## CITY of NOVI CITY COUNCIL

Agenda Item 4  
September 8, 2008

**SUBJECT:** Consideration of a request from JCK Group, applicant for Victor Muscat, for: 1) a variance from Section 11-239(b)(3) of the Design and Construction Standards, which prohibits parking to be located in the road right-of-way, to allow three parking stalls within the Old Novi Road right-of-way; and, 2) a variance from Section 11-276(b) of the Design and Construction Standards, which requires safety paths to be placed along the Old Novi Road frontage in accordance with the Bicycle & Pedestrian Master Plan, to eliminate the requirement for a portion of the safety path along the applicant's Old Novi Road frontage. (The subject property occupies multiple parcels located at 2215 Old Novi Road.)

Project Name Muscat Property - Abode Beauty Salon S.P. #08-18A

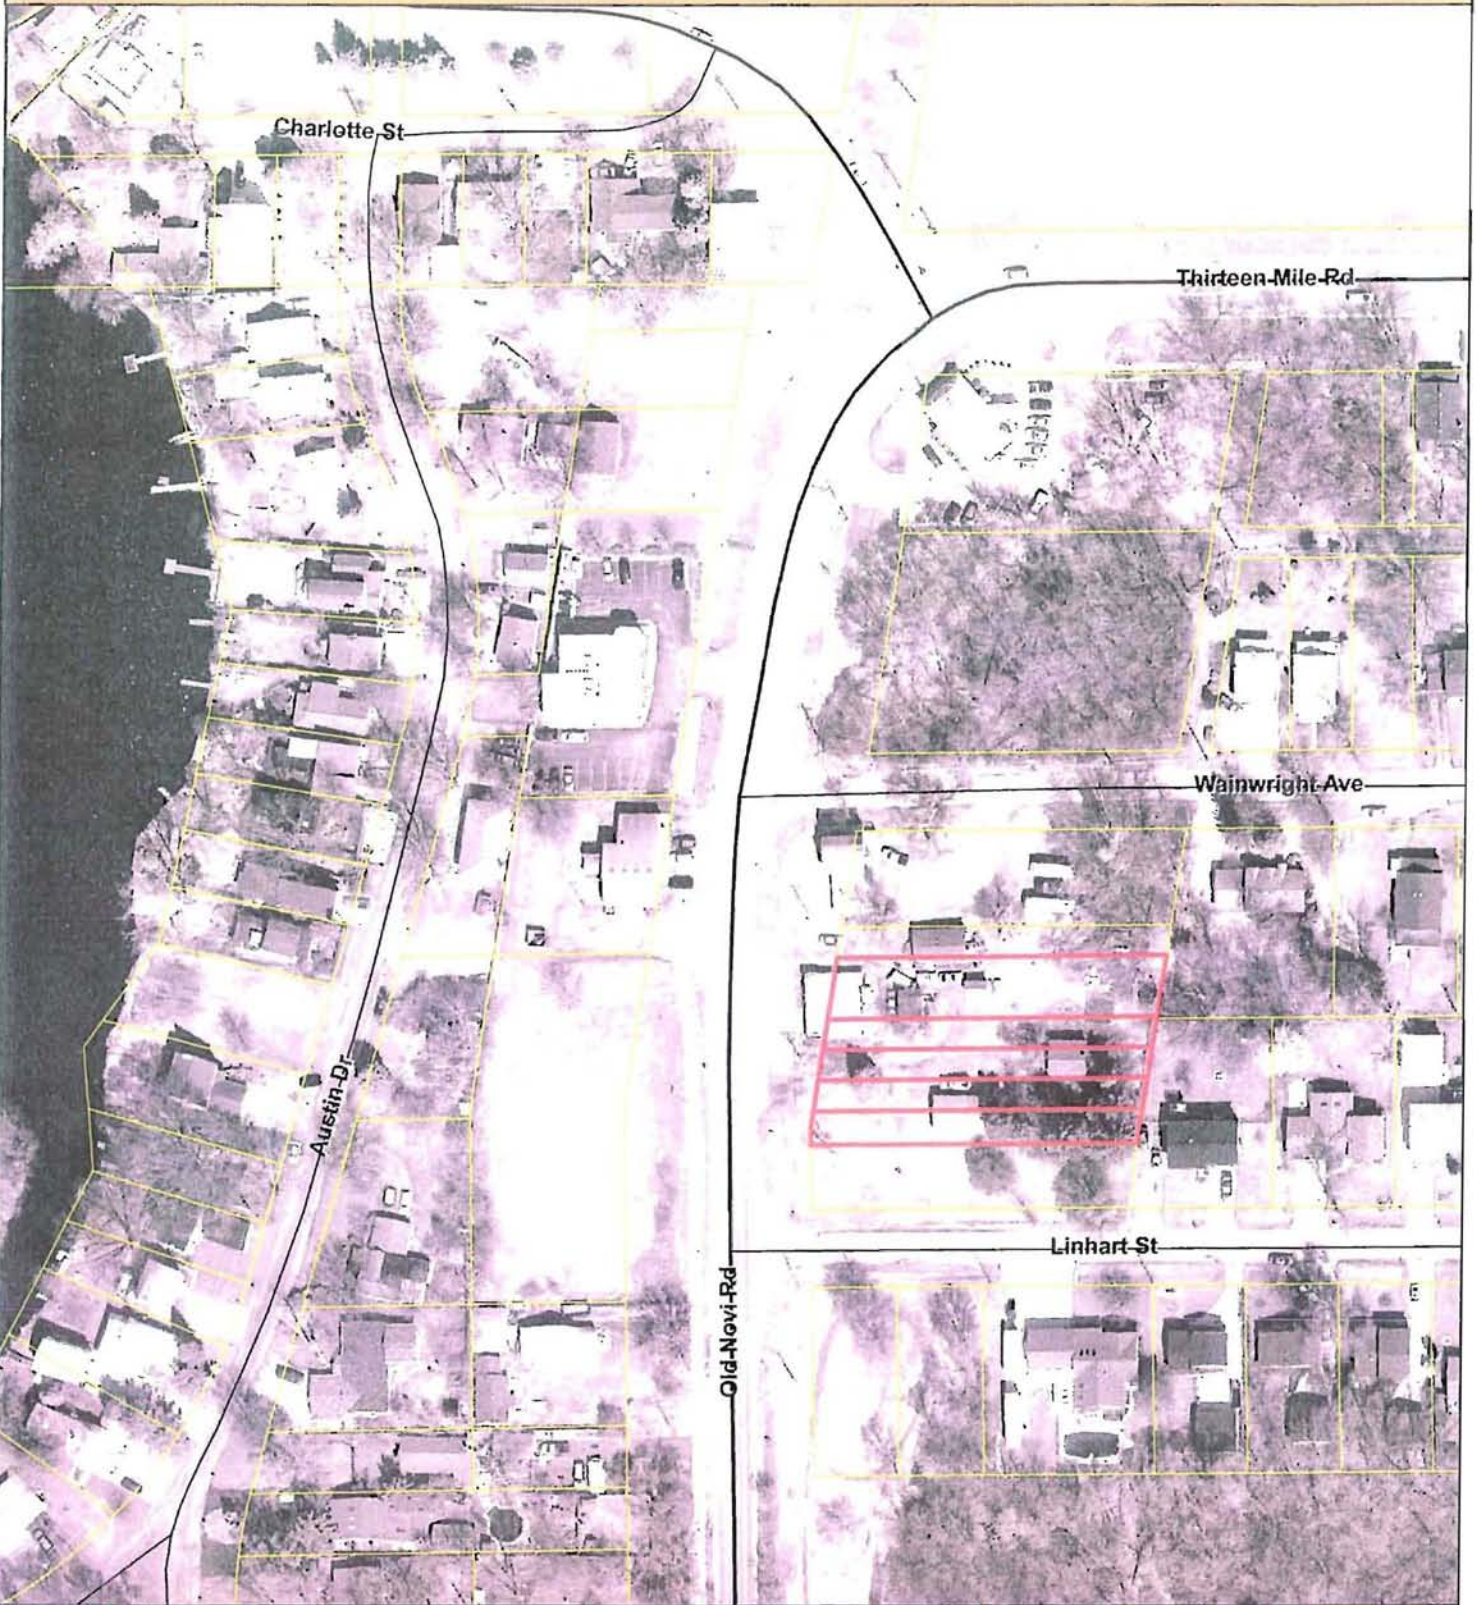
The first part of the request is for a variance from Section 11-239(b)(3) of the Design and Construction Standards, which prohibits parking to be located in the road right-of-way. The variance requested is to permit three parking stalls to be located within the right-of-way of Old Novi Road. The proposed stall locations have historically been used for parking on the unpaved surface. To meet minimum parking space requirements and to preclude the need to extend the proposed parking lot further to the east to preserve a 12-inch diameter spruce tree, the applicant is requesting approval to construct two of the site's parking stalls completely and one stall partially within the Old Novi Road right-of-way.

The Engineering Department notes that the variance requested does not meet the minimum requirements of the Design and Construction Standards; however, given the unusual constraints for this particular site, the proposed development would most likely be an improvement over the existing layout. It is important to note that, although no future capital projects are planned for Old Novi Road, the proposed layout could hinder future work should the road ever be widened to add more lanes of traffic, or to lengthen the center turn lane.

The second part of the request is for a variance from Section 11-276(b) of the Design and Construction Standards, which requires safety paths to be placed along the frontage of the arterial and collector street system in accordance with the Bicycle & Pedestrian Master Plan. The variance requested is to eliminate the construction of 10 linear feet of 5-foot wide pedestrian safety path near the mid-point of the development's frontage on what will be a curbed island. The owner does not want to relocate the existing electrical utility pole that conflicts with the alignment of the proposed path. The proposed path location varies from the standard location of 1-foot inside the right-of-way due to the building's nonconformity as discussed above. Specifically, the path ranges from one foot to roughly 20 feet from the right-of-way line because of the location of the building.

The Engineering Department notes that the variance requested does not meet the minimum requirements of the Design and Construction Standards. However, because of the unique conditions created by the location of the building, Engineering does not object to the request with one minor exception: a second ramp with curb cut should be constructed on the west side of the island. If a vehicle is parked in the handicapped stall, then pedestrians would otherwise have to negotiate the curb to get back on the sidewalk.
